**Date:** April 21, 2021

**From:** John Andreevski, Director (Acting), Community Planning, North York District

**File No.:** A0142/21NY

**Address:** 1356 Mount Pleasant Road

Attachment 1: North Side Elevation

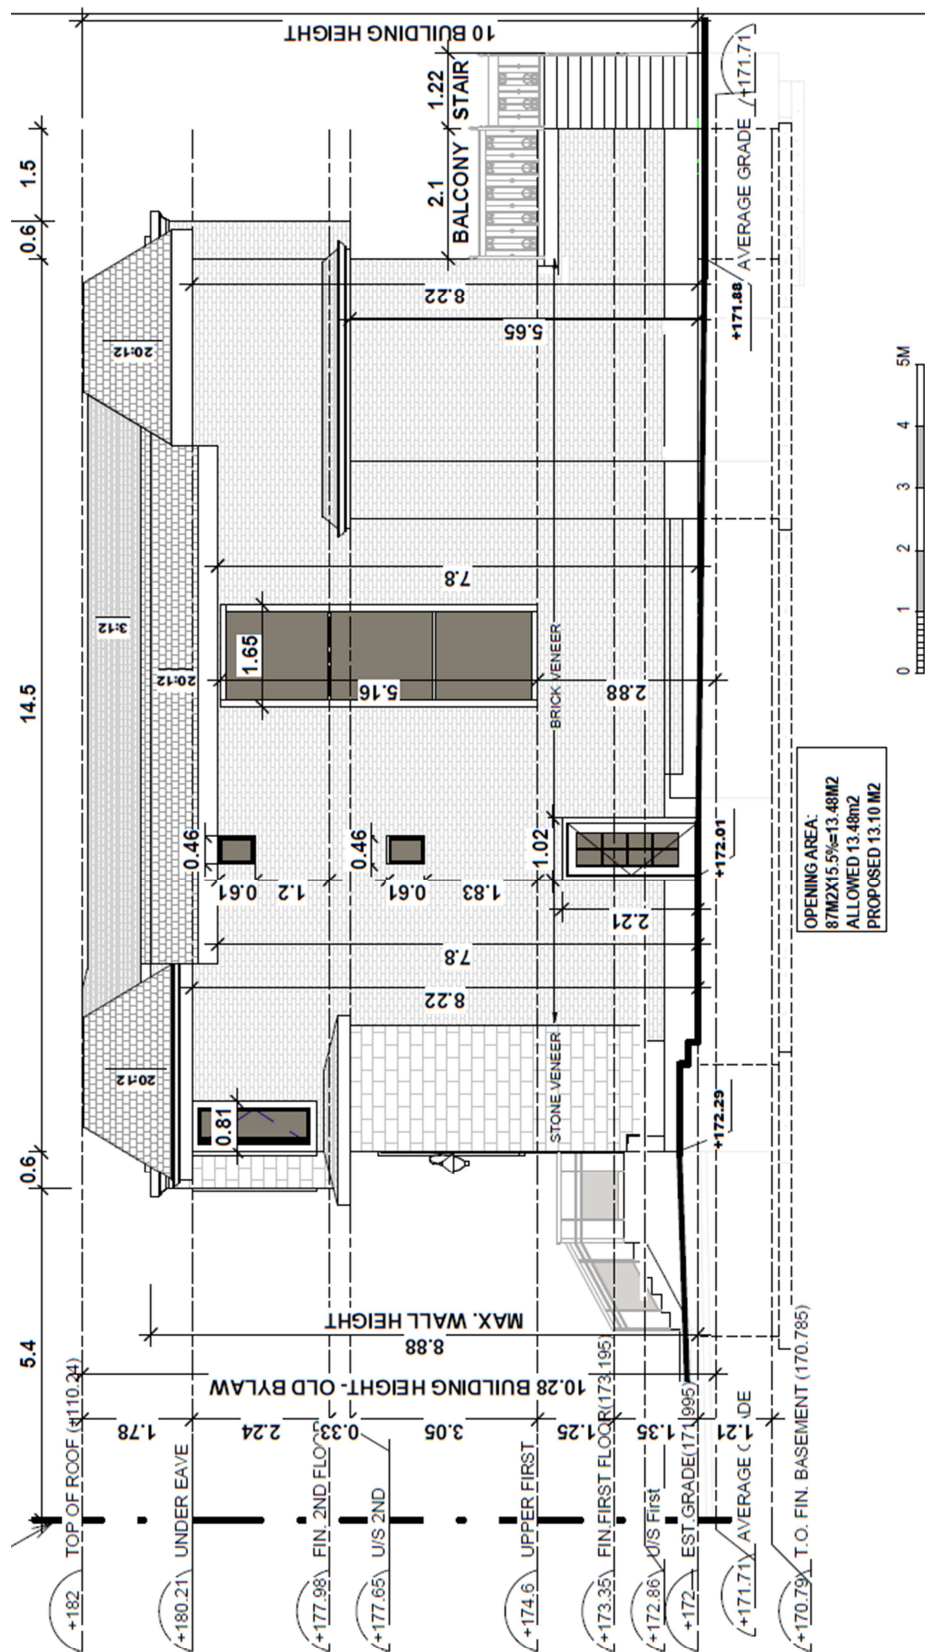
1. The side exterior main wall heights be developed substantially in accordance with the north and south side elevation drawings attached to this report.

The applicant is also requesting a side exterior main wall height of 8.88 metres, whereas the zoning by-law permits a height of 7.5 metres. This is measured based on the box windows on the front and rear main walls that are visible from the side lot lines. Portions of the actual side exterior main walls have heights that range from 7.8 metres to 8.22 metres. Planning staff have no objection to the side wall height as proposed, to ensure the side walls are developed as shown on the plans, Planning staff recommend the proposal be developed substantially in accordance with the north and south side elevation drawings attached.
